Subject: BAR Action - Lee Park 101 E Market Street - October 20, 2015

BAR 15-10-03 Lee Park-101 E. Market Street Tax Parcel 330195000 City of Charlottesville, Owner/Mike Doug Ehman, Parks Division Manager, Applicant Repairs at Lee Park, concrete work, retaining wall and masonry, repair stairs

CITY OF CHARLOTTESVILLE BOARD OF ARCHITECTURAL REVIEW STAFF REPORT October 20, 2015

BAR 15-10-03
Lee Park – 101 E Market Street
Tax Parcel 330195000
City of Charlottesville, Owner/ Doug Ehman, Parks Division
Manager, Applicant
Repairs at Lee Park, concrete work, retaining wall and masonry, repair stairs

Sketch 2 - Existing Retainging Wall at the American Linden Tree

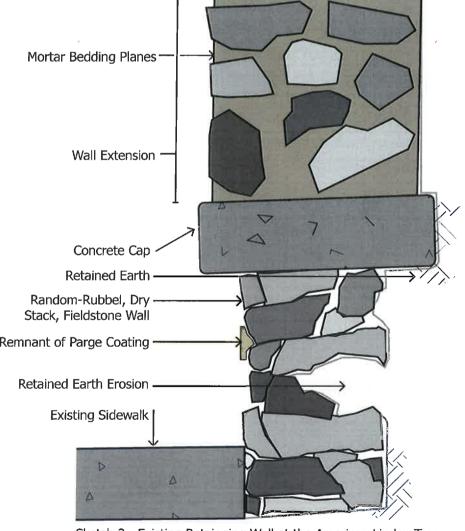
Schwarz moved to find that the proposed Lee Park improvements satisfy the BAR's criteria and are compatible with this property and other properties in the North Downtown ADC district, and that the BAR approves the proposal as submitted, minus the replacement of the wall at the Linden tree.
